From: To: Subject: Date: Louiser bank South
Responses to ExQ1 questions - J L White & Son
04 June 2025 22:59:45
image:004.ong
image:003.ong
image:003.ong
image:010-000 - LVIA page 11 (1).odf

Question LUA 1.6: Sterilised and impractical land

Indicative Landscape Plan

Dogger Bank South Offshore Wind Farms

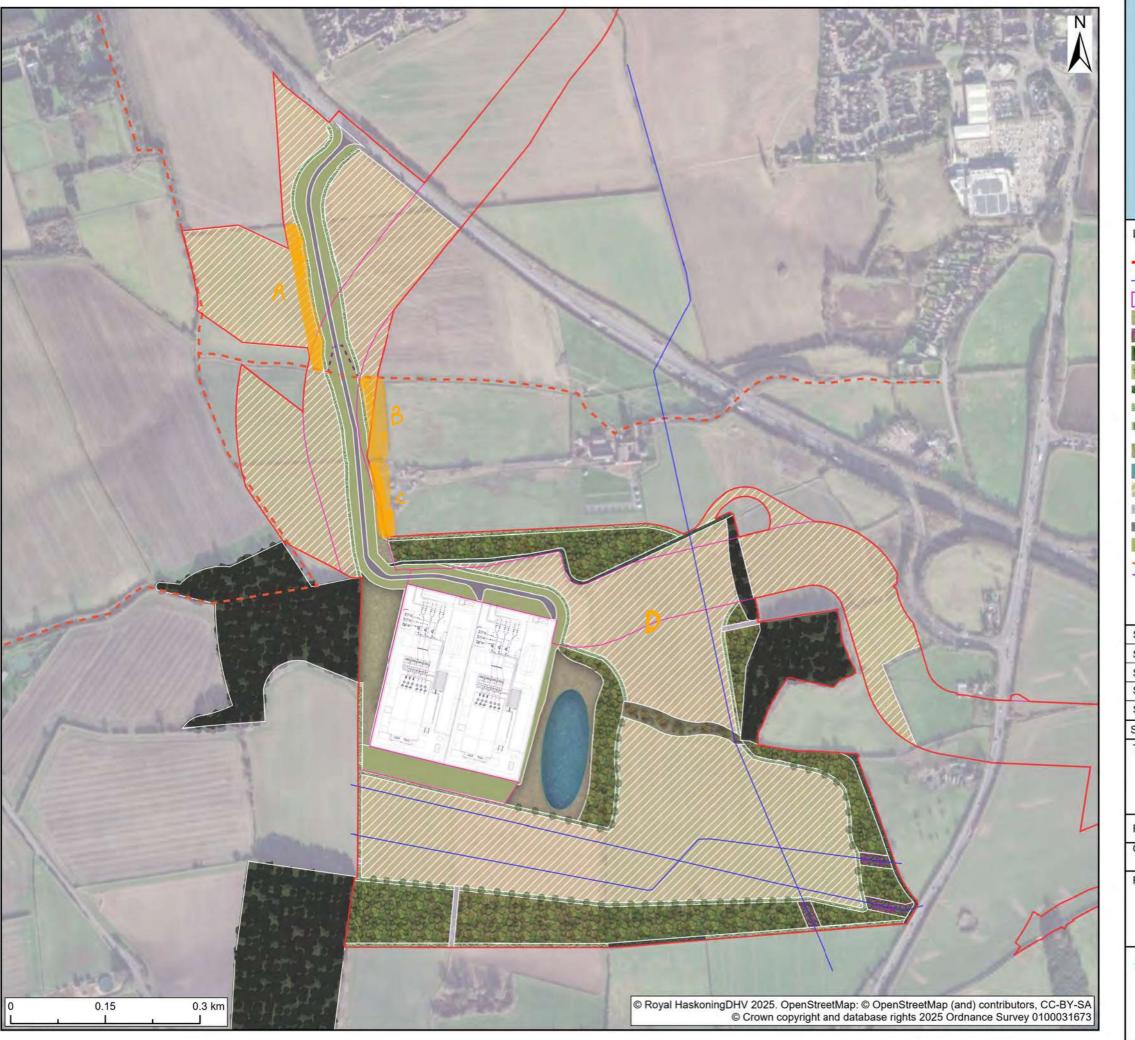
In respect of areas made impractical or sterilised permanently the attached Indicative Landscape Plan ("ILP") shows three areas highlighted orange and marked A, B and C. These areas form part of or adjoin plot 18-010 of the applicants Land Plans and, if the ILP is assumed to be correct the areas left sterilised by the proposed project are the following sizes:

- A 0.58Ha (approx, 20m wide
- B 0.48Ha (approx. 25m wide)
- C 0.30Ha (approx. 25m wide)

All three of these areas currently form part of larger arable fields and will be severed due to the project. The size of modern agricultural machinery leaves these areas completely impractical to farm following completion of the project.

I should also like to point out the area D on the attached plan is forms part of plot 18-010 which is included within the book of reference as being required for freehold acquisition. The ILP suggests that the majority of this area will be returned to agriculture but parts of this area could result in being impractical to farm due to final arrangement on the ground.
